Proposed Updates to pittala_3ct_01a_0120

IEEE P802.3cw TF Interim Teleconference Meeting
August 23, 2021

- nicholl_3cw_01a_210809 suggested general updates to pittala_3ct_01a_0120 (see next page)
- This presentation provides detailed changes to the adopted slides in pittala_3ct_01a_0120
- Recommendation:
 - Replace slides 5-9 of pittala_3ct_01a_0120 with slides 5-10 of nicholl_3cw_01a_210823 to enable correlation for the definition of a transmitter quality metric

Fig. 1 Measurement setup for OSNR penalty vs EVM for non-equalizable noise like impairment.

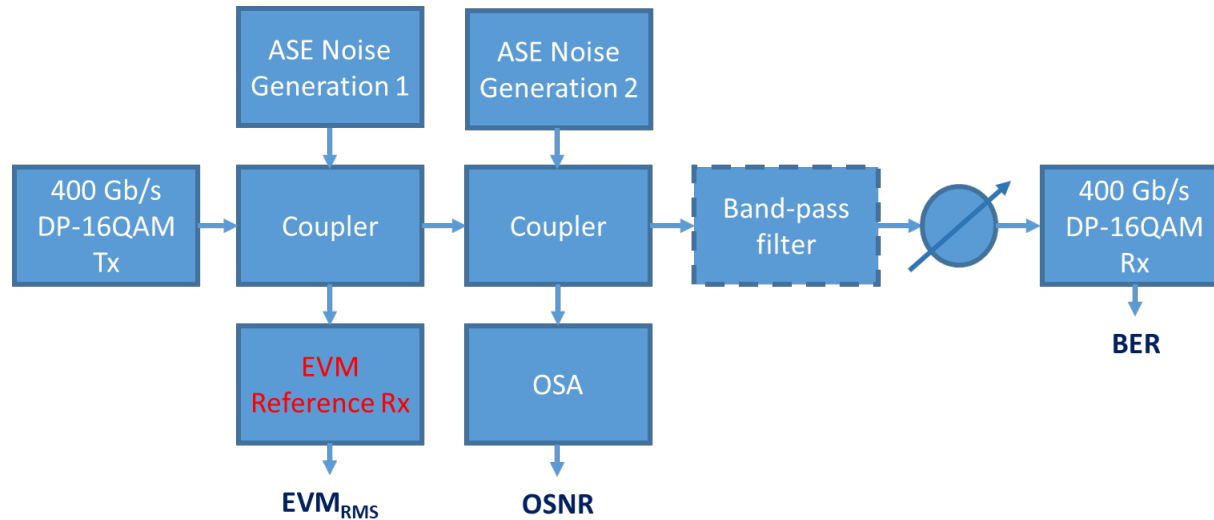
The measurement setup in Fig. 1 (for noise like impairment) and the one in Fig. 2 (for non-equalizable or equalizable impairments) should be used to test if the following parameters can be covered by EVM:

- I-Q offset;
- Quadrature error;
- I-Q imbalance;
- I-Q skew;
- Non-linearities;
- non-equalizable impairment like circle-like noise (zero mean noise with fix magnitude and incremental phase) as shown in [anslow 3cn 01 181025](#);
- non-equalizable noise like impairment;

EVM Reference Rx

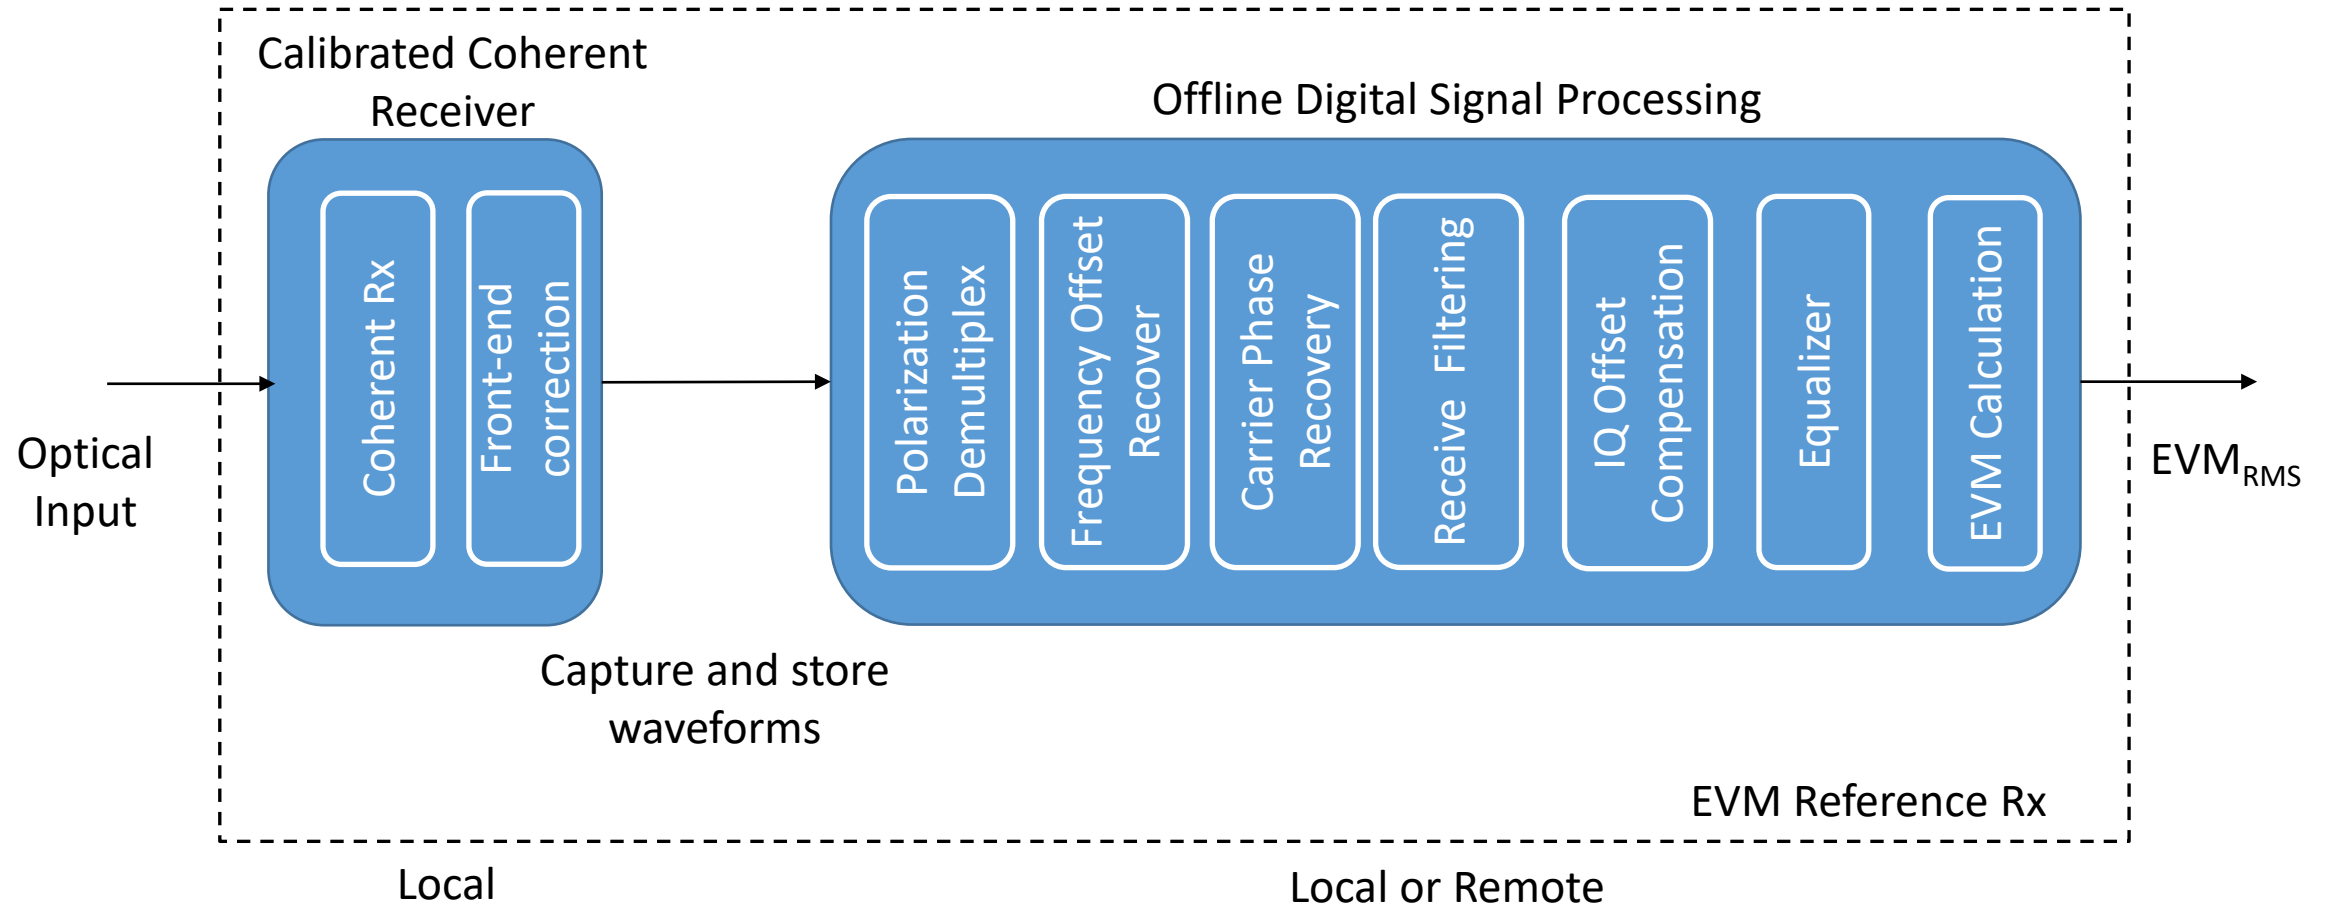
- Calibrated coherent receiver: always “local” to transmitter under test
- Offline digital signal processing: can be either “local” or “remote” to transmitter under test

Measurements based on setup in Fig. 1

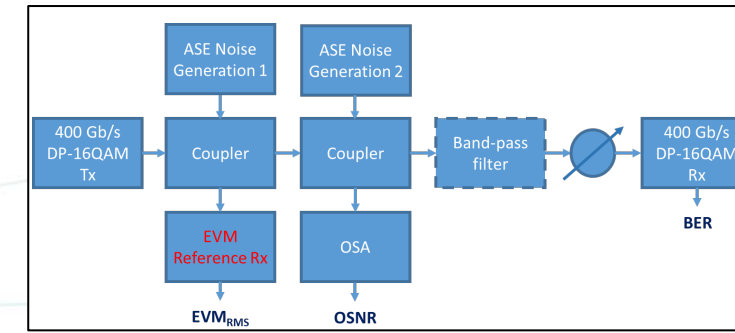
If measuring non-equalizable noise-like impairment using the setup in Fig. 1 the following steps are used:

- 1) Without ASE noise generation 1, adjust the ASE noise generation 2, to get the considered pre-FEC BER of $1.25e-2$; then first EVM_{RMS} and OSNR values are measured (EVM_0 , $OSNR_0$).
- 2) a) Introducing ASE noise generation 1 and measure EVM_{RMS} (EVM_1), the pre-FEC BER is changed (not $1.25e-2$ anymore), b) then adjust the ASE noise generation 2, to set pre-FEC BER at $1.25e-2$ again, then turn-off ASE noise generation 1 and then the second OSNR value is measured ($OSNR_1$), the OSNR penalty is ($OSNR_1 - OSNR_0$).
- 3) Change the ASE noise generation 1, and repeat the step 2), more EVM_{RMS} and OSNR values are measured.
- 4) The curve of OSNR penalty versus EVM_{RMS} is obtained.

Measurements based on setup in Fig. 2

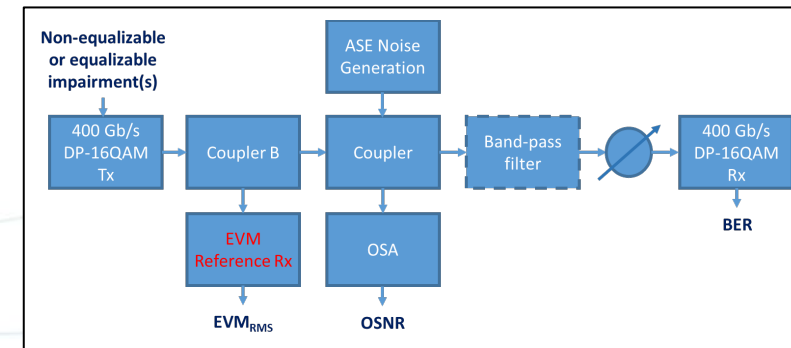
It is preferred that measurements are obtained independently for each parameter, i.e as the effect of varying one parameter is being measured the other parameters remain unchanged.

Using IQ offset as an example the procedure is:

- 1) Adjust the ASE noise generation, to get the considered pre-FEC BER of $1.25e-2$; then first EVM_{RMS} and OSNR values are measured (EVM_0 , $OSNR_0$).
- 2) a) Modify the transmitter to give a certain value of IQ offset and b) measure EVM_{RMS} (EVM_1), the pre-FEC BER is changed (not $1.25e-2$ anymore), then adjust the ASE noise generation, to set pre-FEC BER at $1.25e-2$ again, then the second OSNR value is measured ($OSNR_1$), the OSNR penalty is ($OSNR_1 - OSNR_0$).
- 3) Modify the transmitter to give a certain value of IQ offset and repeat the b) part of step 2), more EVM_{RMS} and OSNR values are measured.
- 4) The curve of OSNR penalty versus EVM_{RMS} is obtained.
